**Response To Community
Comments On Ameren
Missouri Corrective Measures
Assessments For Rush Island,
Labadie, Sioux And Meramec
Energy Centers**

SUMMARY OVERVIEW

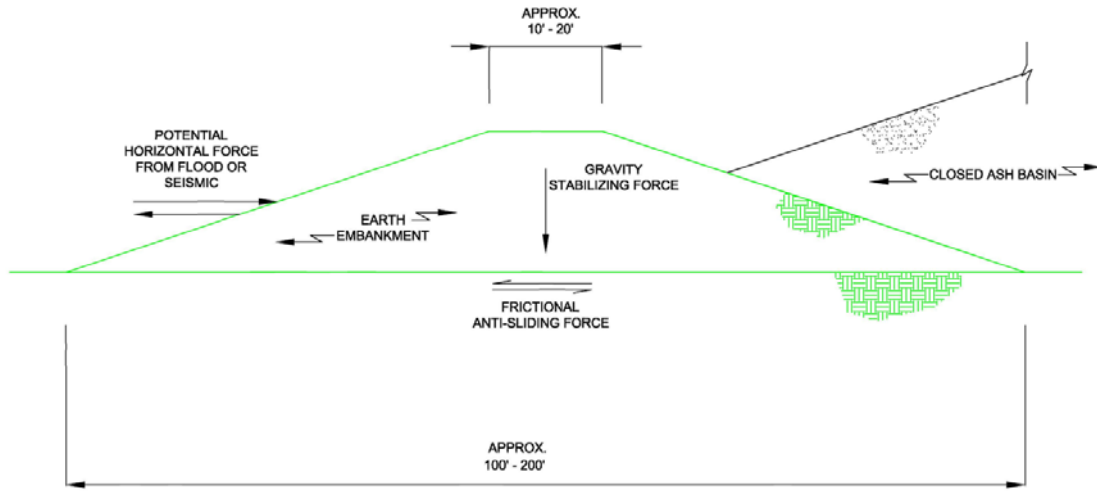
WUELC argues, seemingly based on a CSX marketing brochure that it references, that rail transport would avoid local impacts to the community inherent in truck hauling and therefore

- *Logistical Issues Impact Reliability of Rail.* Due to the haul cycles and load/unload times, a single unit, 100-car train is capable of transporting at most one load per week.

Nine (9) unit trains would be required to to maintain parity with trucking estimates of 5,000 tons per day. The cost of procuring such trainsets is approximately \$90M (\$100,000 per car x 9 unit trains). Interruptions with multiple railroad crews or service anywhere along the haul routes, rail yards or energy centers would disrupt shipments. Based on Ameren's experience with coal deliveries, it is highly unlikely that the rail carriers could consistently maintain such productivity.

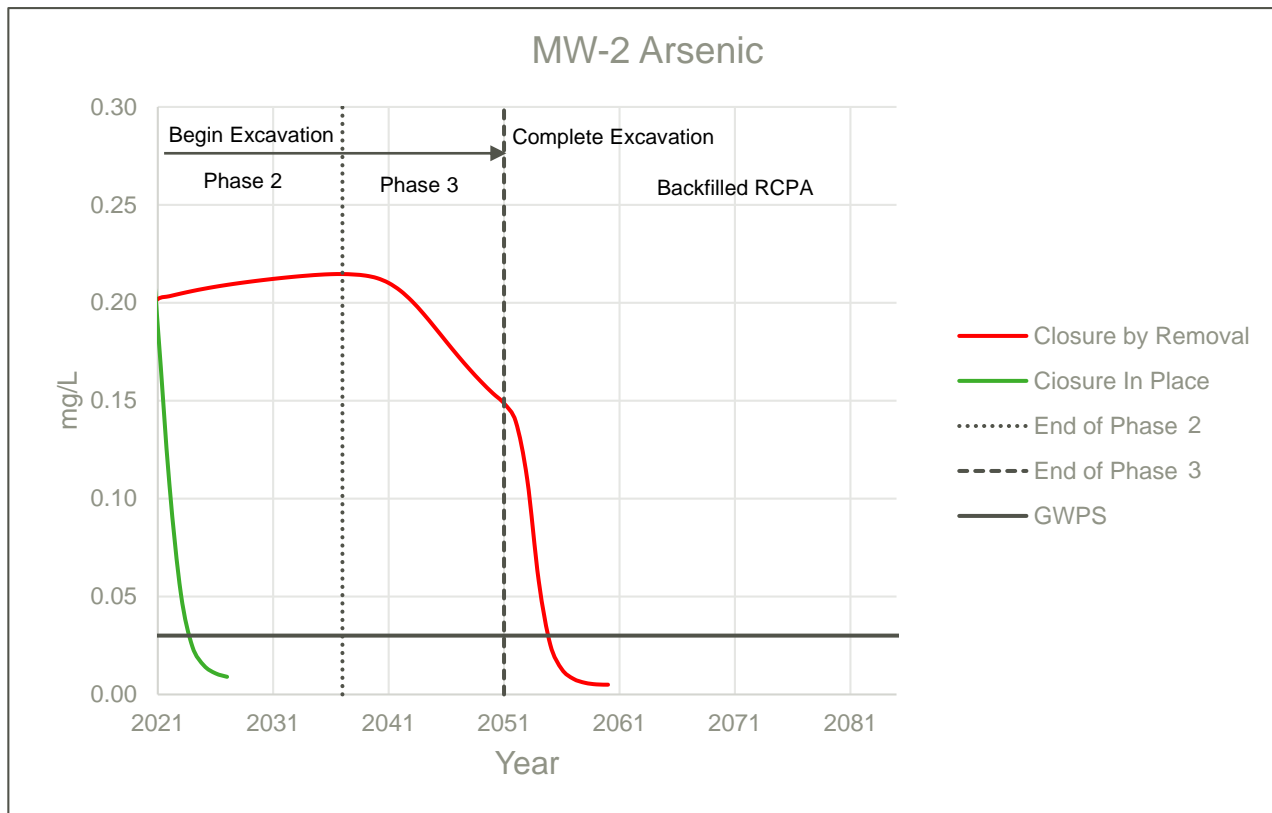
11. **Excavation Would Delay Compliance Until After 2050**

MW-2 (highest arsenic value in CCR Rule Well) is estimated to reach the GWPS 30 years sooner using closure in place vs closure by removal (Excavation)
